Planning Commission

**October 24th, 2018
1ST FLOOR CONFERENCE ROOM
4:30 P.M.
AGENDA**

APPLICATION FOR SITE PLAN APPROVAL
FOR HOLIDAY INN EXPRESS EXPANSION AT
1931 CLEVELAND ROAD

Reference Number: PC-21-2018

PARKING LOT SITE
CLEVELAND ROAD WEST
WARD 2, CITY OF SANDUSKY, ERIE COUNTY, OHIO

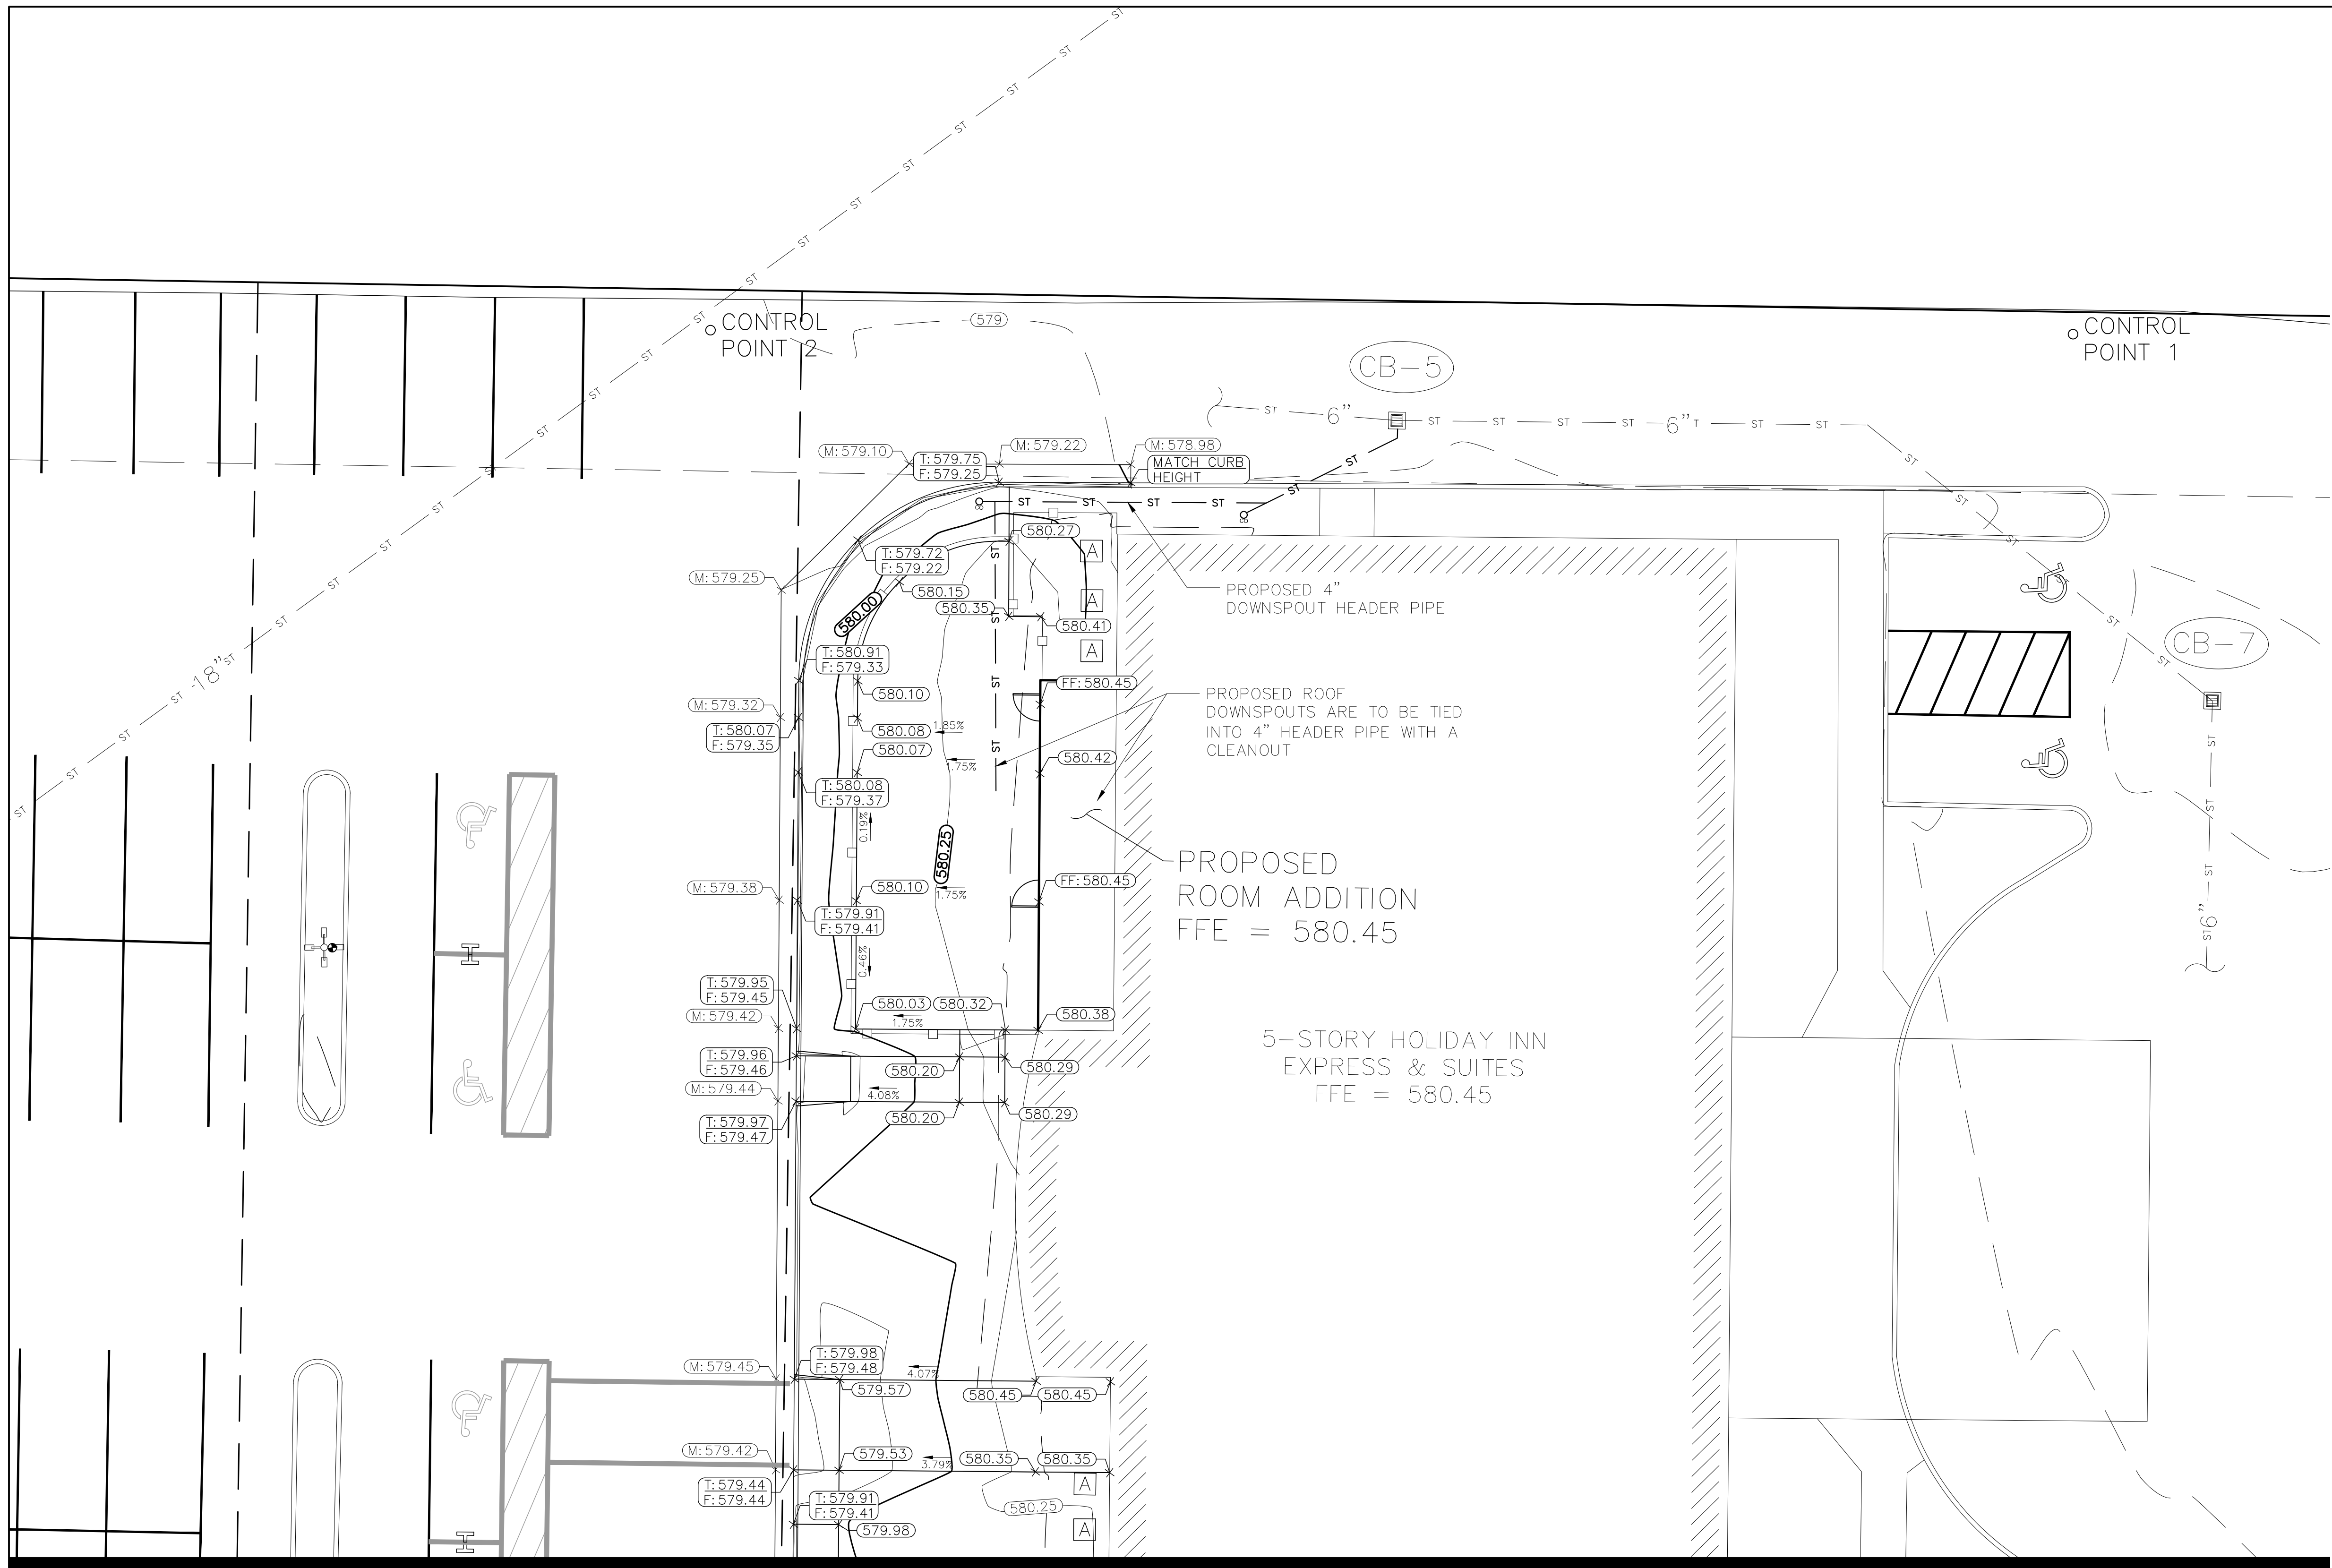
As noted above, per the letter of the code, the proposed and existing uses would require 372 parking spaces and the applicant is proposing 320 spaces. However, it is important to note that section 1149.06 of the code does allow for combined uses of parking facilities: “A building, or group of building, containing two or more uses, operating during the same hours, and which are different off-street parking requirements, shall provide spaces for not less than the sum of the spaces required for each use...”. However, the applicant is stating that the users of the hotel are also users of the bowling alley and the restaurant bar, thus reducing the need for spaces. Staff believes that the applicant is meeting the intent of the code because a large percentage of the hotel guests are also utilizing the other uses as “hotel accessory uses”. While there are some overlap in operating hours, not all the uses do not normally operate normally during the same hours thus allowing for shared parking. The applicant feels confident that they have more than enough parking on site due to the high amount of parking required per lane in regards to a bowling alley. The applicant will also provide 60 overflow parking spaces directly across the street (as seen in the image below), which would bring the proposed parking to 361 total parking spaces.

Proposed location of overflow parking spaces.

1. Although the applicant has indicated that overflow parking will be available across the street staff recommends restriping the overflow parking area.
2. The plan be revised, for staff approval, showing location and placement of landscape items to be located in landscaped areas, per 1149.09
3. Parking blocks shall be utilized for the most southern spaces in the new parking are located at the North West portion of the site and a 3' landscaped strip shall be installed above mentioned spaces and the existing parking to the south.
4. The lighting shall be in conformance with section 1149.10 and a revised cut sheet shall be submitted for staff approval that shows the lens being parallel to the ground.
